CONSTRUCTION SUMMARY			RECEIVED	
Legacy Hill - Trinigroup Development Inc.				
PURCHASERS: Annie Mei Ying LAI and Kennic Shiu Kan FONG			MAY 30 2024	
TEL:				
LOT / PHASE	REG. PLAN #	HOUSE TYPE		
110 / 1		Villa 6 Elev 1

Villa 6 36' Lot

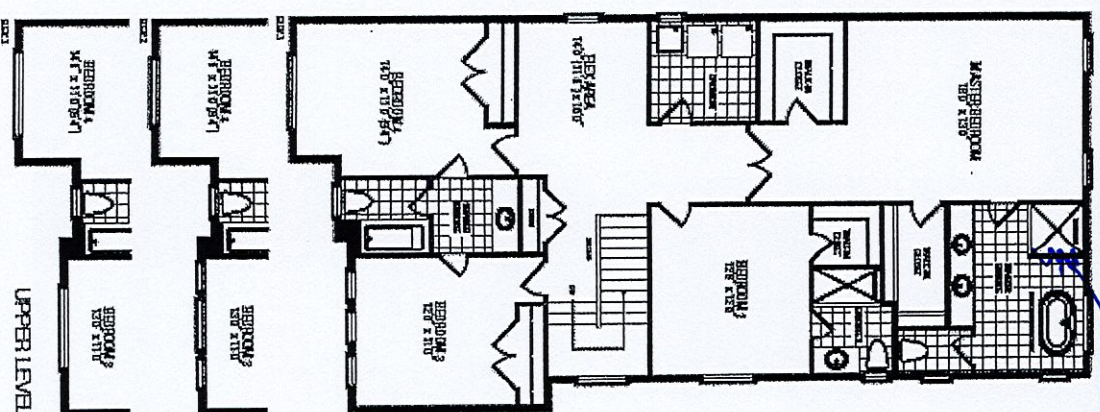
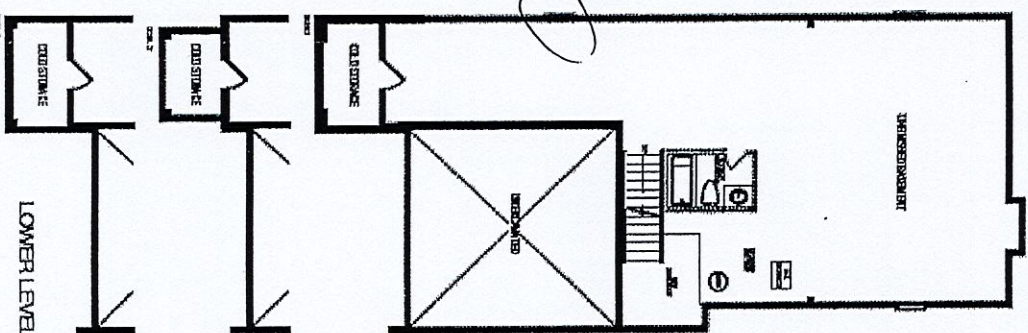
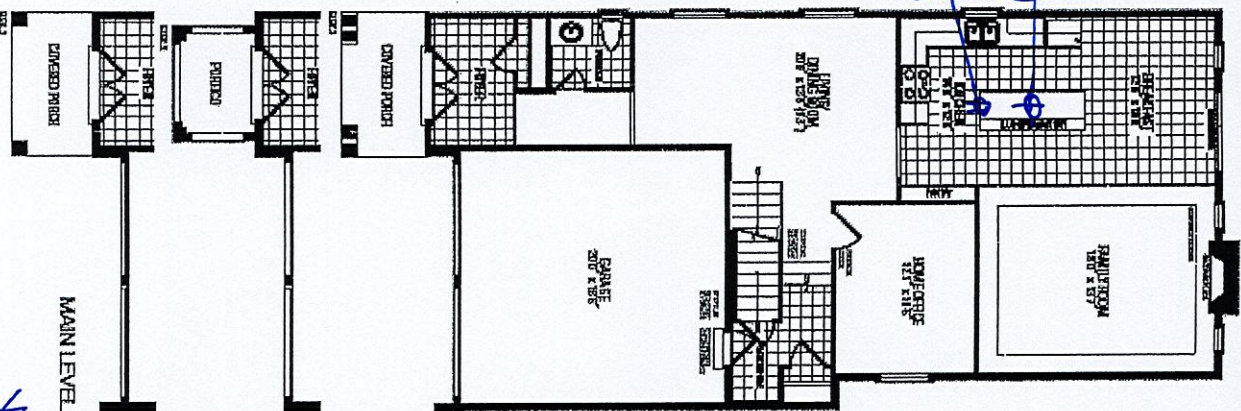
Relocate Standard Kitchen
Light center over Island
Add Plug to Island

* 10 ft Ceiling 1st Fl. *
* 8 ft 6 in Concrete Pour Basement

Frameless Glass
Shower Enclosure

Enlarge Windows

* Smooth Ceilings 1st & 2nd Floors *
